Re: *Proposed Assessment Monitoring Work Plan*
North Mecklenburg C&D Landfill – Closed Phase I and Phase II
Solid Waste Permit Number 60-13
DIN 19520

The Solid Waste Section has completed a review of the *Proposed Assessment Monitoring Work Plan* dated August 5, 2013 (DIN 19487) and submitted by Enviro-Pro, P.C. on behalf of Greenway Waste Solutions for the North Mecklenburg C&D Landfill – Closed Phase I and Phase II. The *Proposed Assessment Monitoring Work Plan* was submitted in accordance with the 15A NCAC 13B .0503 and the 15A NCAC 2L rules in response to a confirmed volatile organic compound exceedance within the groundwater monitoring wells at the facility.

RE: Proposed Assessment Monitoring Work Plan
North Mecklenburg C&D Landfill
19300 Holbrooks Road
Huntersville, North Carolina
Permit #60-13
Job No. EP-1217(A)

PROPOSED ASSESSMENT MONITORING WORK PLAN

APPROVED BY: **SLB**
DATE: **AUG. 2013** DWG SCALE: **1"=200'** PROJECT NO: **111-370.0001** FIGURE NO.: **1**

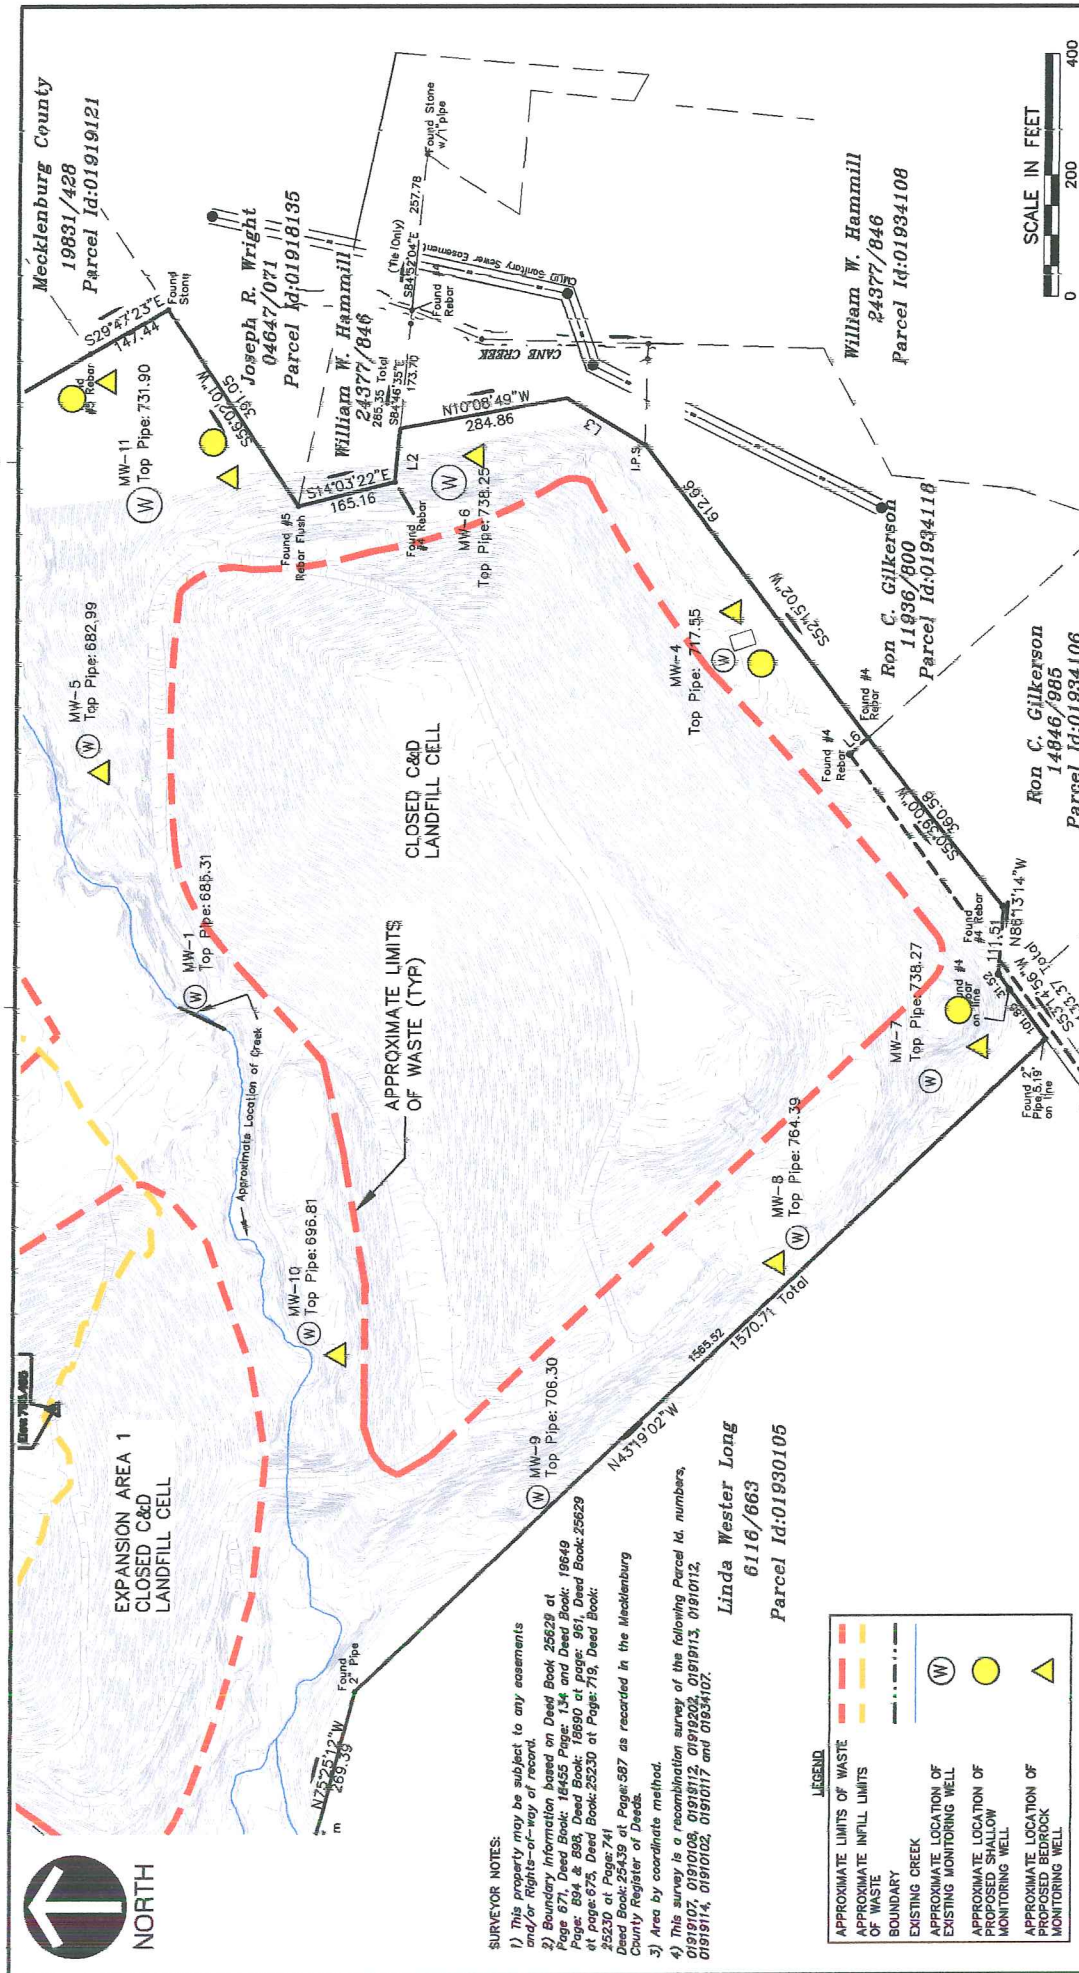
Four new shallow and eight new bedrock groundwater monitoring wells will be installed at the facility. The new groundwater monitoring wells will be developed and in-situ permeability testing will be conducted to determine aquifer characteristics. Finally, the new groundwater monitoring wells in addition to the existing groundwater monitoring wells will be sampled for the parameters included within Appendix I of 40 CFR Part 258.

As a result, the *Proposed Assessment Monitoring Work Plan* is approved as described. If you have any questions or concerns regarding this letter, please feel free to contact me at 919-707-8294 or by email at jaclynne.drummond@ncdenr.gov. Thank you for your continued cooperation with this matter.
